RECALL H506/N908 – INGENIUM I6 3.0L OIL FILTER ELEMENT CAP - RENEW

SAFETY RECALL N908/H506 – INGENIUM I6 3.0L OIL FILTER ELEMENT CAP - RENEW

SAFETY RECALL N908: AJ20-P6 Engine Oil Filter Housing Cracked

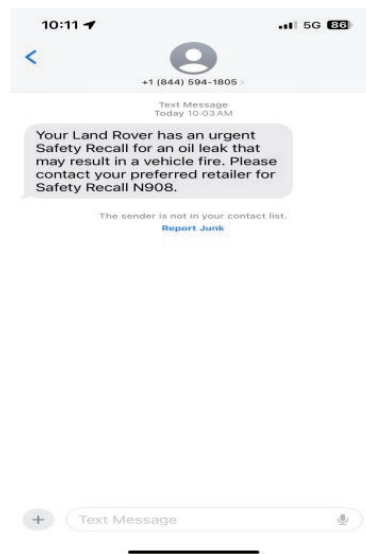
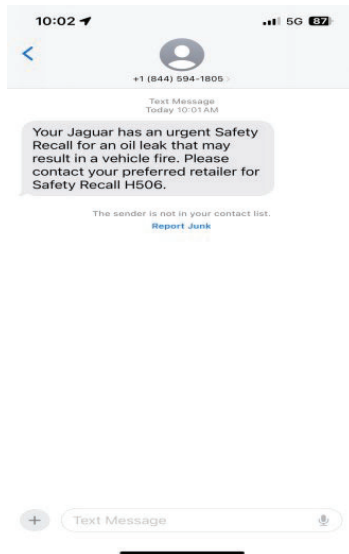
AFFECTED MODELS	24MY F-PACE 24MY Range Rover, Range Rover Sport, Range Rover Velar, Defender, and Discovery
VOLUME AFFECTED	US 2151 CAN 152
REPAIR	A concern has been identified where the incorrect specification of plastic was used to manufacture the oil filter housing. The incorrect specification plastic housing will, over time and with vehicle use, crack allowing oil to leak out onto the engine and into the engine compartment. An oil leak under pressure in this area could result in oil contact with hot components on the engine, which may result in a fire. Additionally, oil may leak onto the road surface posing a skid hazard to other road users, especially two wheeled vehicles, and increase the risk of a crash. Replacement of the oil filter and filter housing are required.
REPAIR TIME	0.2 hrs + DIDO
CAMPAIGN LAUNCH	Quarantine Notification released on June 11th, 2024 Recall Repair Bulletin launched on June 14th, 2024 On July 5th, 2024, an update to the repair bulletin has been made to include an option code for mobile technician repairs (travel and recall repair). 100% of parts requirement for US deployed by Tues 9th July 100% of Canadian requirement will be deployed by Fri 12th July

Your authorized Land Rover retailer will replace the oil filter housing, complete with filter and associated o-rings. There will be no charge to the owners for this repair.
